## ADDENDUM NO. 1

Date: August 2, 2018

Project: State Training School  
Masonry Repairs  
DAS RFB #091835088  
DAS Projects 8914.00 / 8980.00

SHEET  
**A1-21**

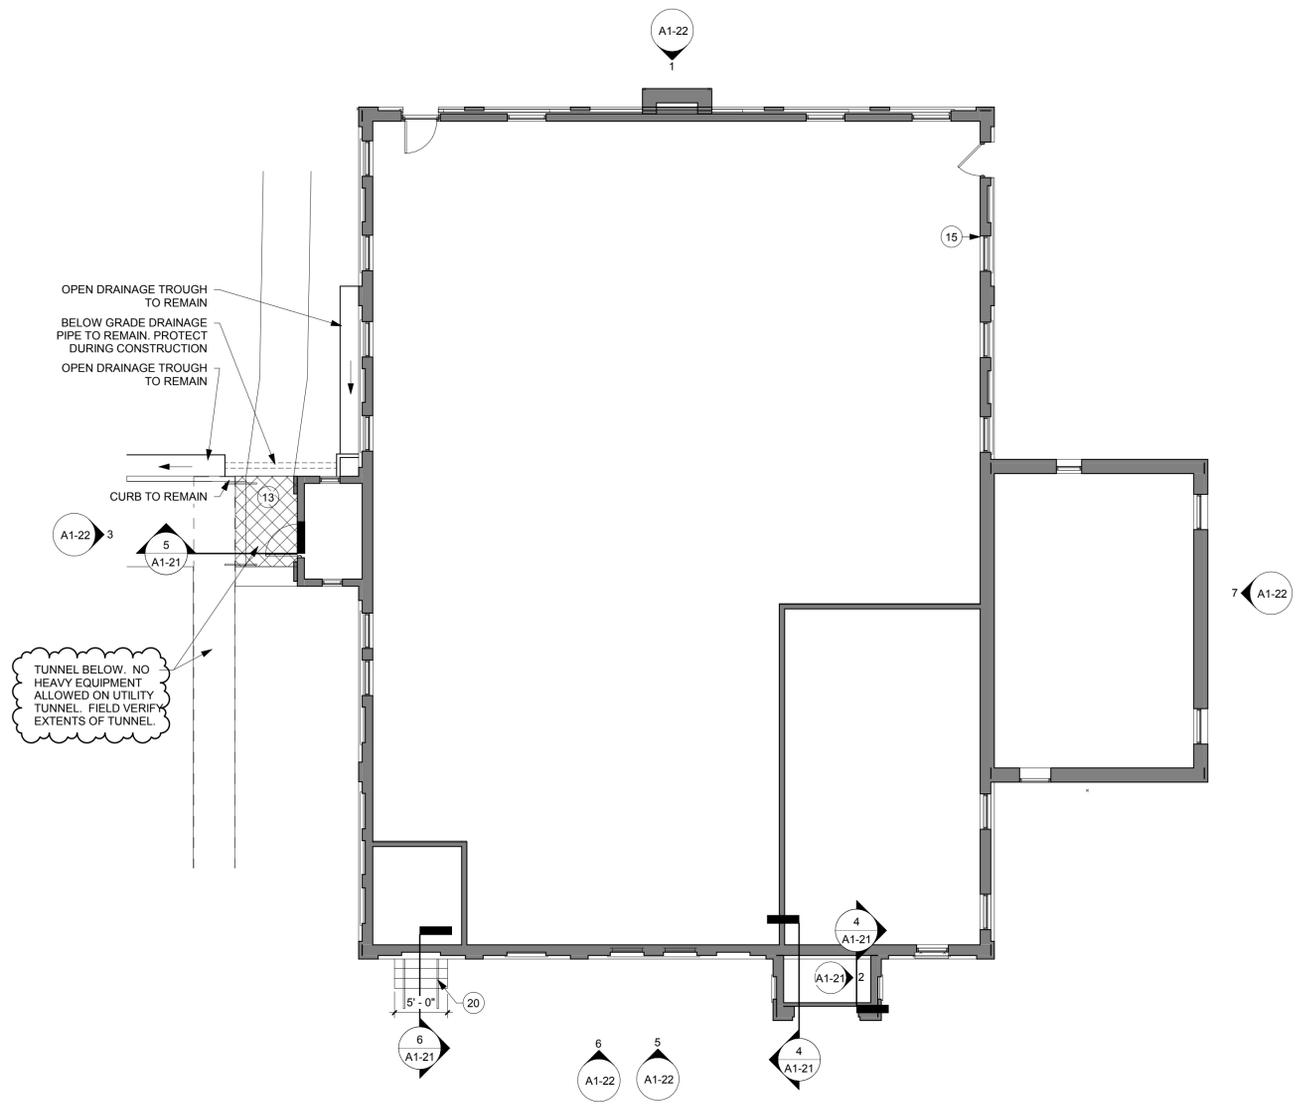
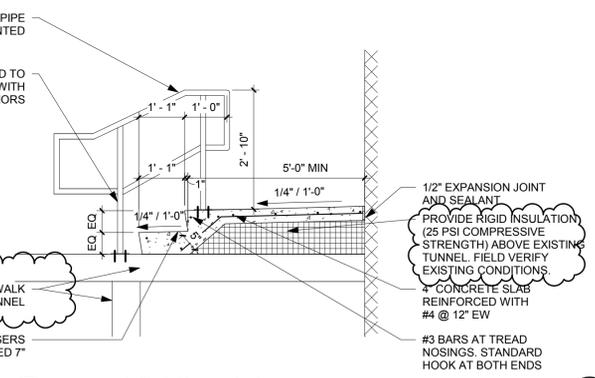
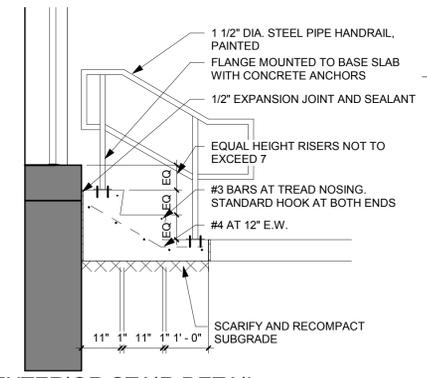
1. Sheet A1-21
  - a. Note added to indicate that “No heavy equipment allowed on utility tunnel. Field verify extents of tunnel.”
  - b. Detail 5/A1-21 modified to indicate that utility tunnel extends below stairs and slab to be placed above rigid insulation.

SHEET  
**A1-22**

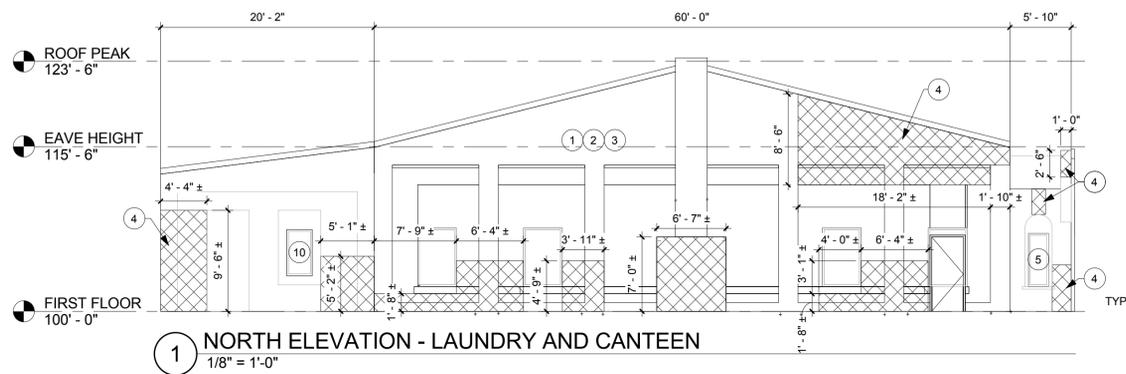
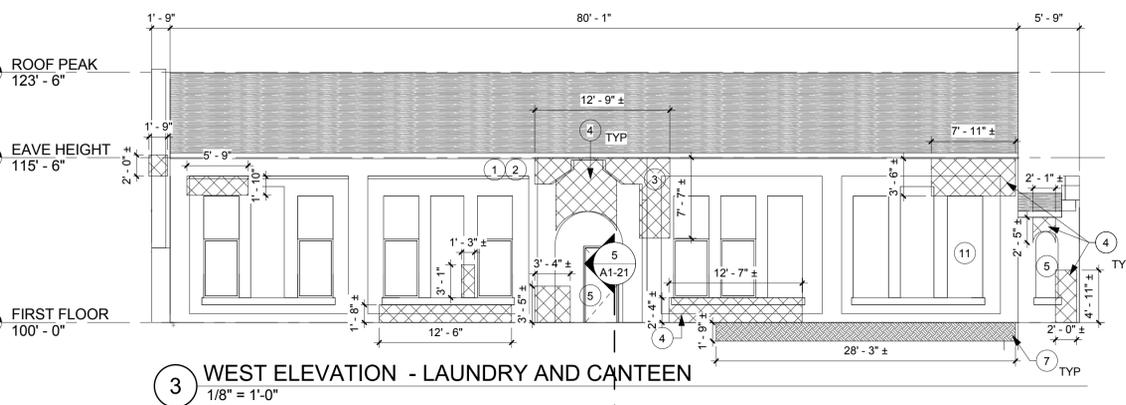
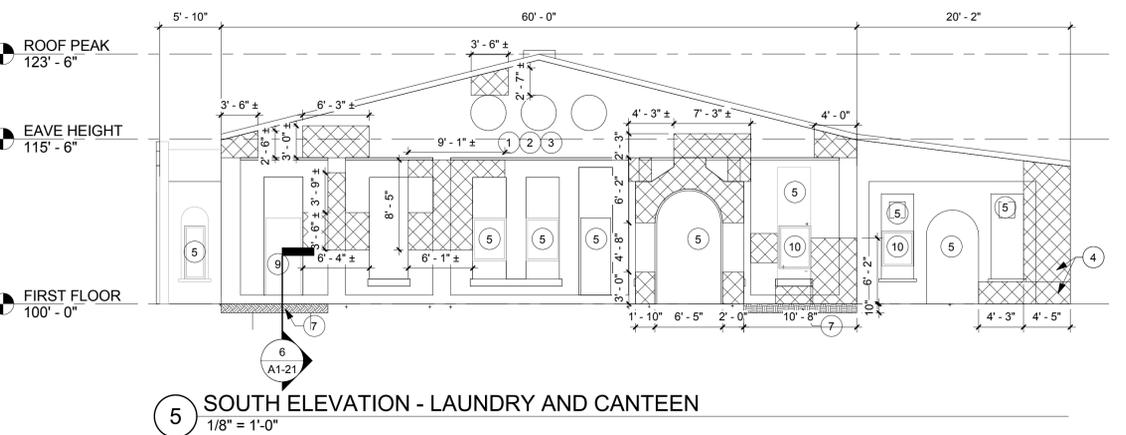
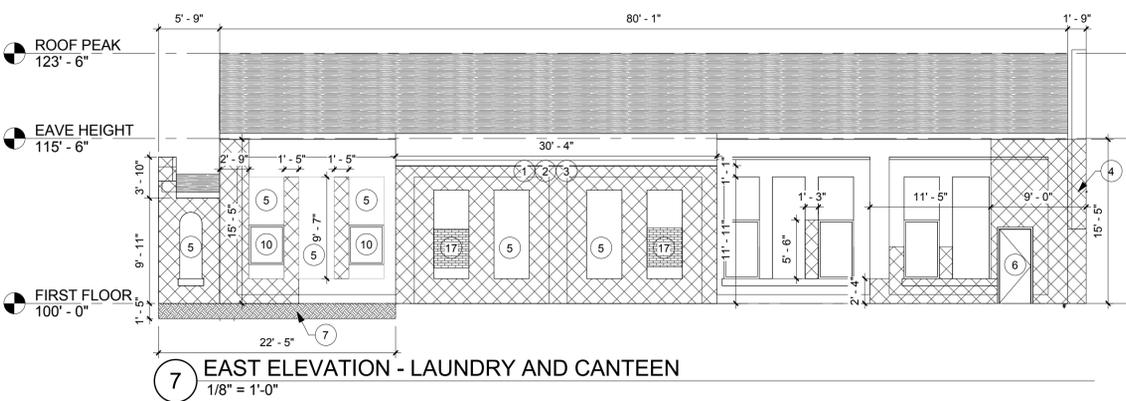
2. Sheet A1-22
  - a. Keynote 5 modified to state “Remove all exterior and interior existing sealant and any backing materials, clean and install new backer rod and sealant around window frames, louvers, door frames, and at joint between exterior wood panel and brick.”

- b. Keynote 17 modified to indicate that the existing window infill is 12” thick (three wythes) at the Laundry / Canteen building.
3. Sheet A1-24
  - a. Add keynote 21 which indicates that “contractor shall carry 100 square foot additional tuckpointing in base bid outside of hatched areas at Boilerhouse.”

SHEET  
**A1-24**

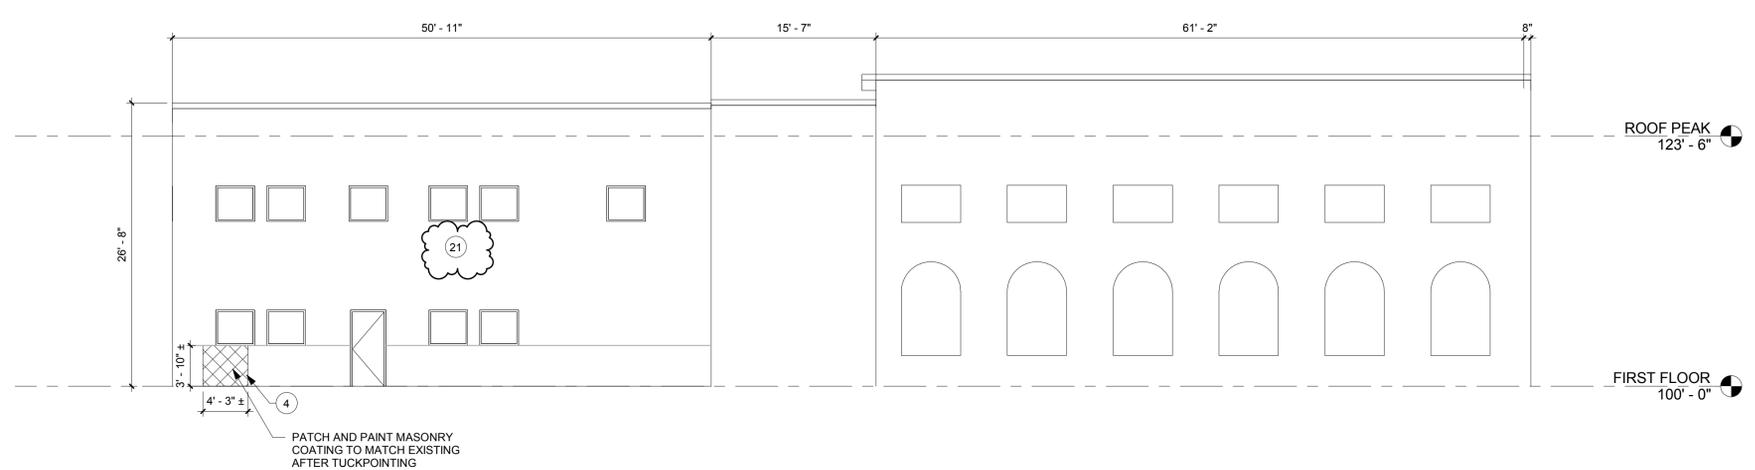
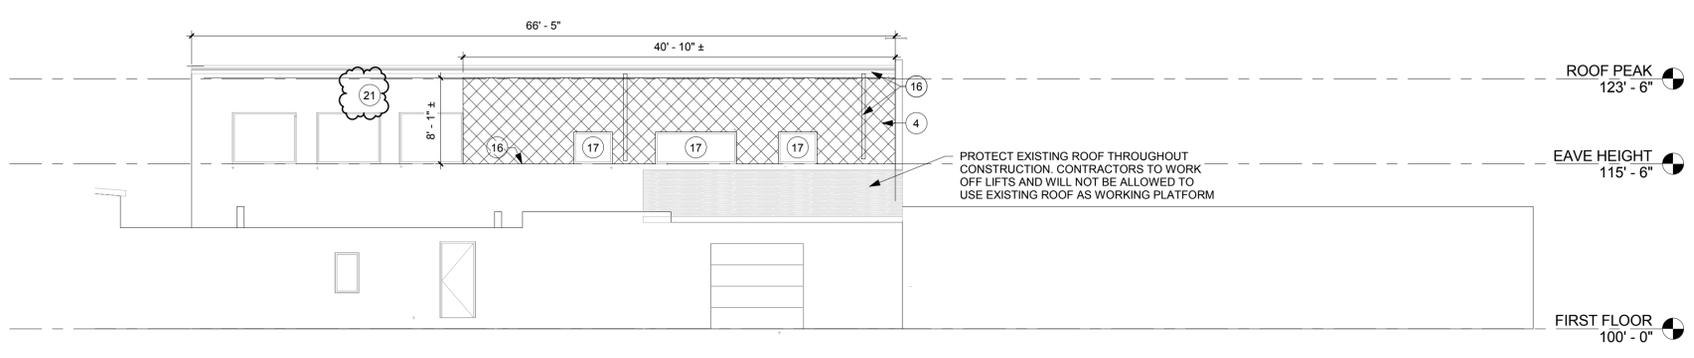
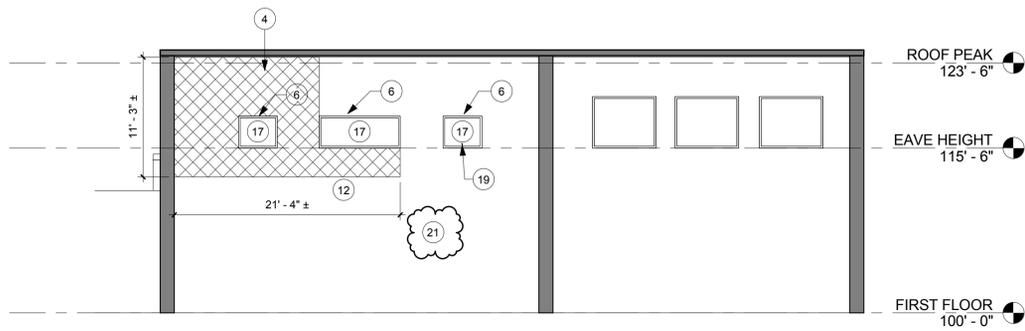
- Q5. Reference Keynote 16 on Sheet A1-24 - Can brick be tuckpointed up to the existing metal siding / trim at the Northeast corner of the Boilerhouse?

- b. Keynote 17 modified to indicate that the existing window infill is 16” thick (four wythes) at the Boilerhouse.
4. Sheet A1-25
  - a. Add keynotes to elevation photos to indicate electrical conduit that is to remain, to be removed by contractor and that is to be removed by facility prior to mobilization.

- A5. A portion of the existing metal siding/trim will need to be removed to provide masonry repair at building corner as indicated on details 1 and 3 on A1-24.

**INTERIOR ELEVATIONS BOILERHOUSE**

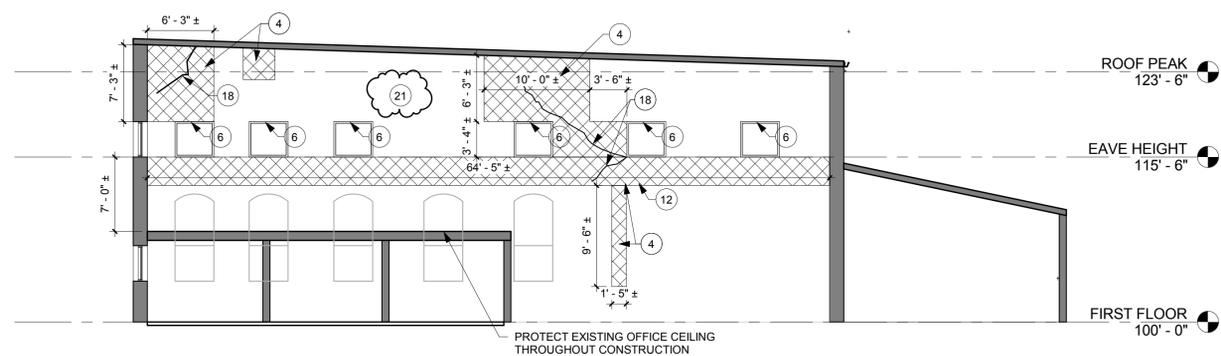
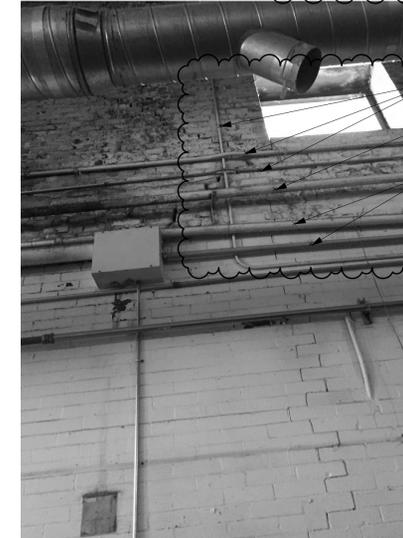
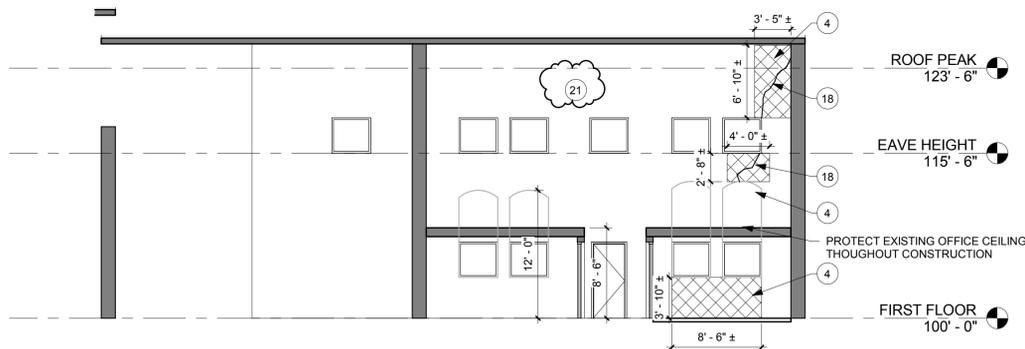
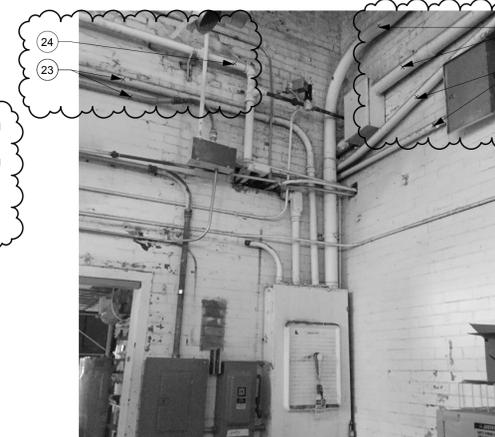
1. Sheet A1-25
  - a. The interior white paint of the Boilerhouse Building has tested positive for lead. The State of Iowa will remediate the affected areas prior to mobilization.

- b. Add keynote 21 which indicates that “contractor shall carry 100 square foot additional tuckpointing in base bid outside of hatched areas at Boilerhouse.”

- c. Keynote 17 modified to indicate that the existing window infill is 16” thick (four wythes) at the Boilerhouse building.
